**CONSTRUCTION CONTRACT CHANGE ORDER NUMBER:** \_\_\_\_\_

CCSJ:	<u>0921-02-321</u>
Project:	<u>STP 2021(256) MM</u>
Highway:	<u>Mile 3 N</u>
County:	<u>Hidalgo</u>
District:	<u>21-Pharr</u>
Contract Number:	<u>C-20-294-02-23</u>

## Change Order #5 Mile 3 N Road

Project: Mile 3 N Road  
Project #: STP 2021 (256) MM  
Contract: C-20-294-02-23  
CSJ: 0921-02-321  
Limits: Tom Gill Road to FM 492 (Goodwin Road)

**MILE 3 ROAD  
PLAN AND PROFILE  
STA. 235+50 TO STA. 240+50**

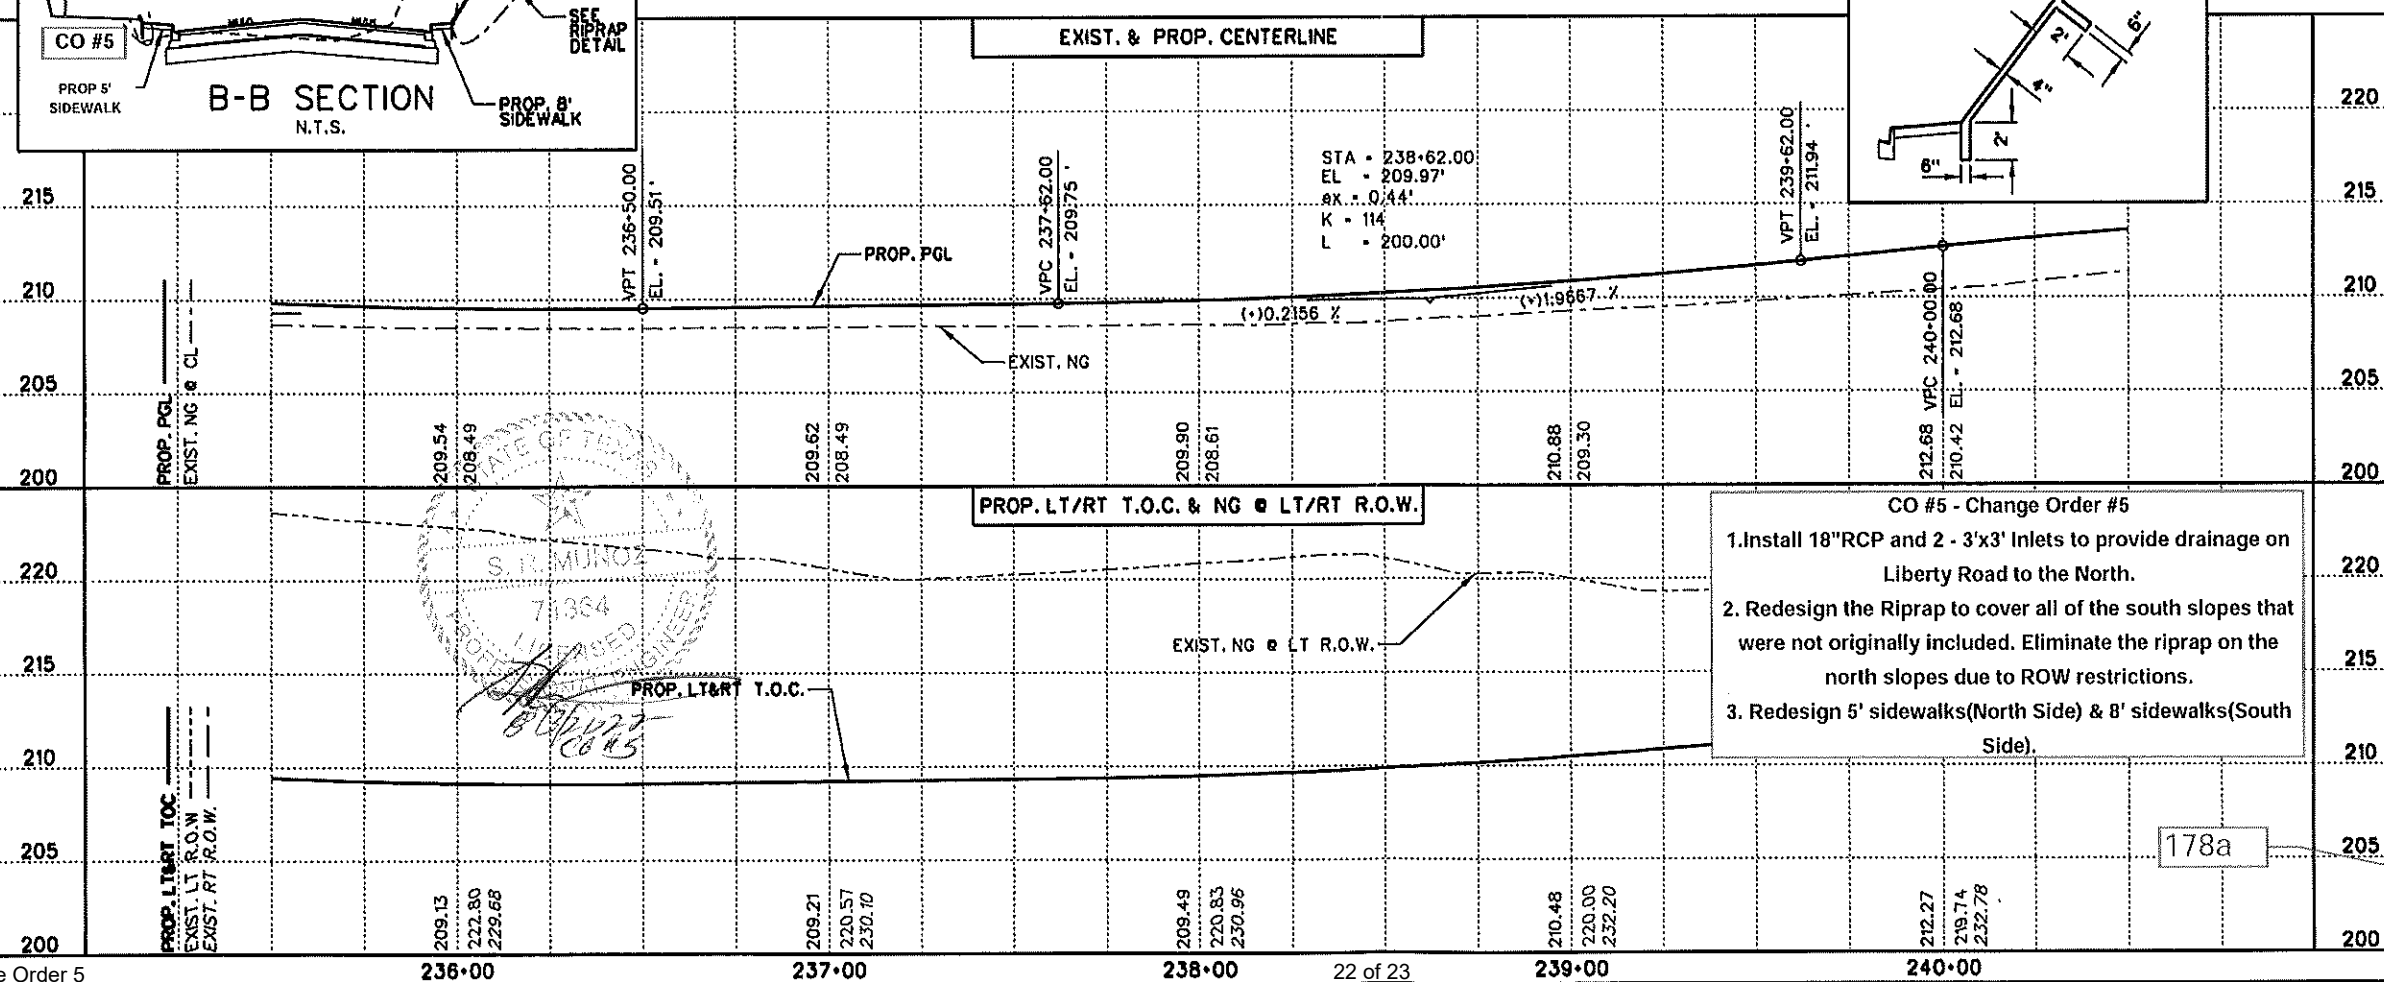
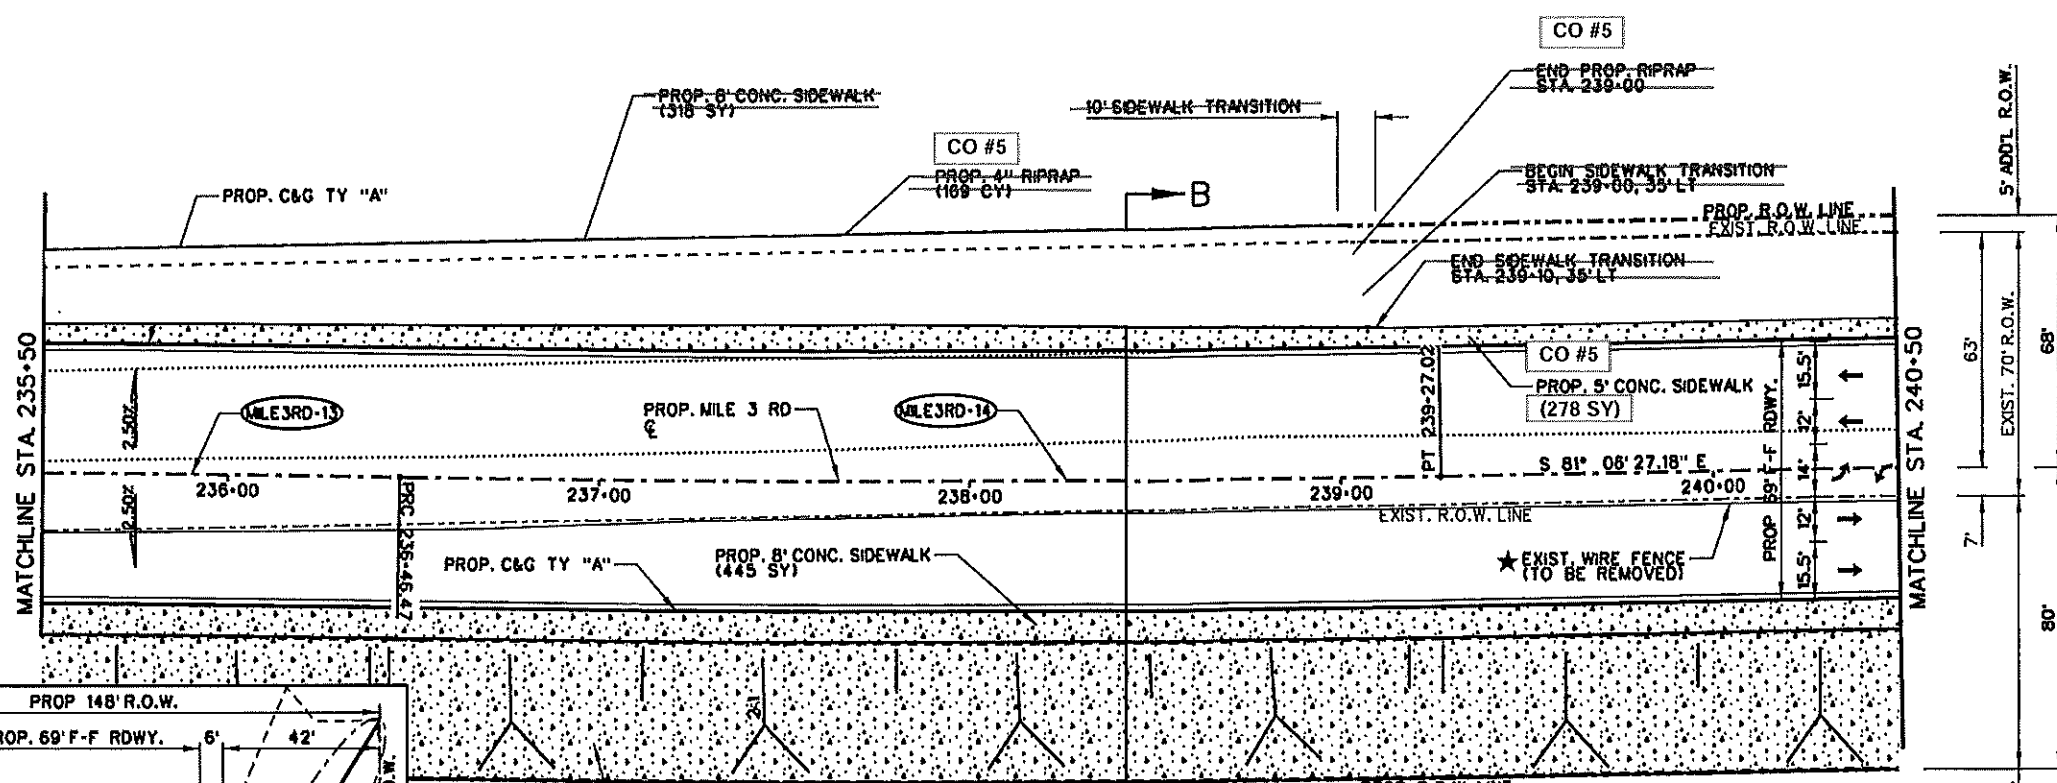
- Install 18" RCP and 2 - 3'x3' Inlets to provide drainage on Liberty Road to the North.
- Redesign the Riprap to cover all of the south slopes that were not originally included. Eliminate the riprap on the north slopes due to ROW restrictions.
- Redesign 5' sidewalks (North Side) & 8' sidewalks (South Side).
